UNITED STATES
DEPARTMENT OF THE INTERIOR
BUREAU OF LAND MANAGEMENT

FORM APPROVED
OMB NO. 1004-0137
Expires: January 31, 2018**SUNDRY NOTICES AND REPORTS ON WELLS**
*Do not use this form for proposals to drill or to re-enter an abandoned well. Use form 3160-3 (APD) for such proposals.*5. Lease Serial No.
NMNM067896

☐ Oil Well ☒ Gas Well ☐ Other8. Well Name and No.
W SHUGART 19 FED 22. Name of Operator
MARATHON OIL PERMIAN LLCContact: MELISSA SZUDERA
E-Mail: mszudera@marathonoil.com9. API Well No.
30-015-30501-00-S13a. Address
5555 SAN FELIPE ST
HOUSTON, TX 770563b. Phone No. (include area code)
Ph: 713-296-317910. Field and Pool or Exploratory Area
N SHUGART

Permanent Abandonment of Federal Wells
Conditions of Approval (LPC Habitat)

**** BLM REVISED ** BLM REVISED ** BLM REVISED ** BLM REVISED ** BLM REVISED ****

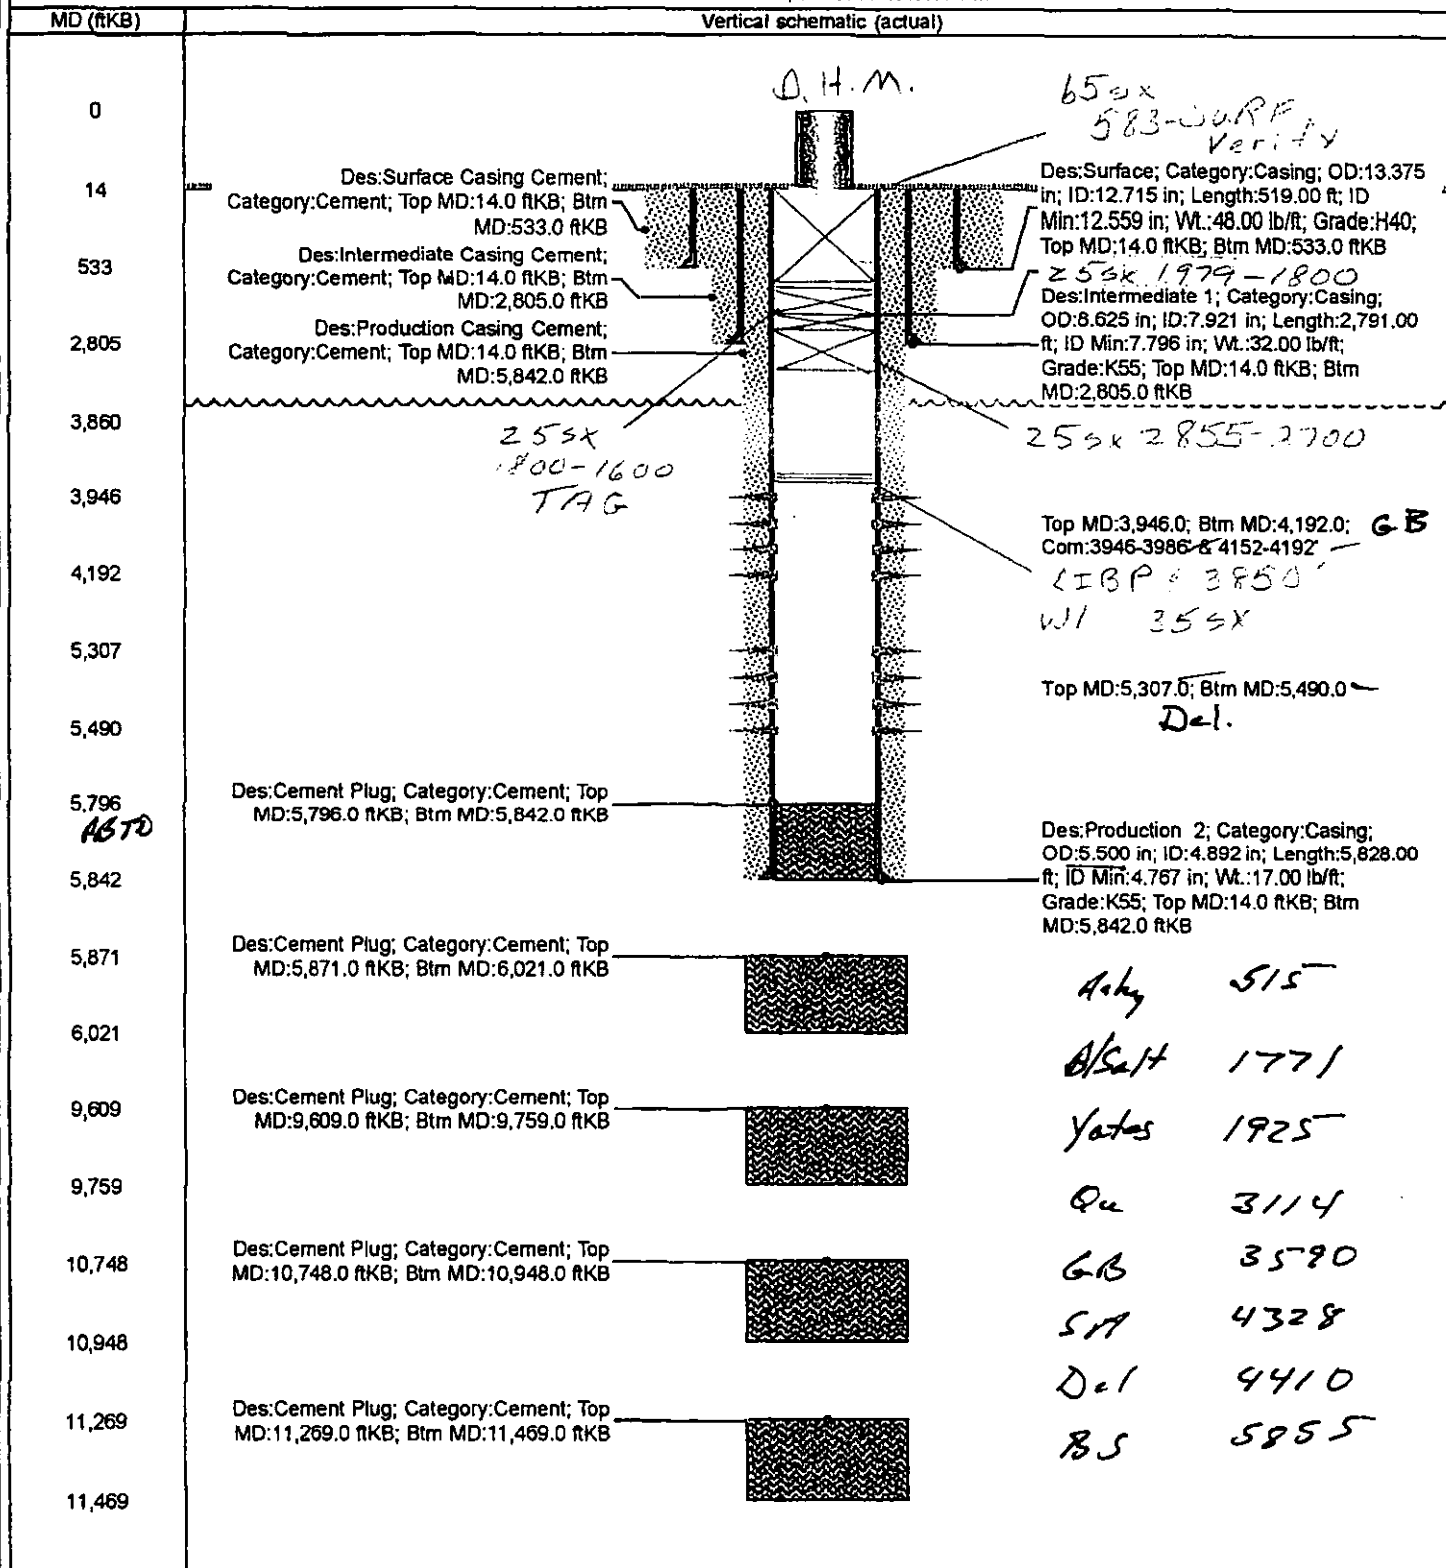
Set 5-1/2 CIBP @ 5257. Dump Bail
35' cent. WOC Tag covers Top Perf (Del).
Spot 25 sx Plug @ 4378 - 4238. Tag
Top Del.

Below ground level dry hole marker required!
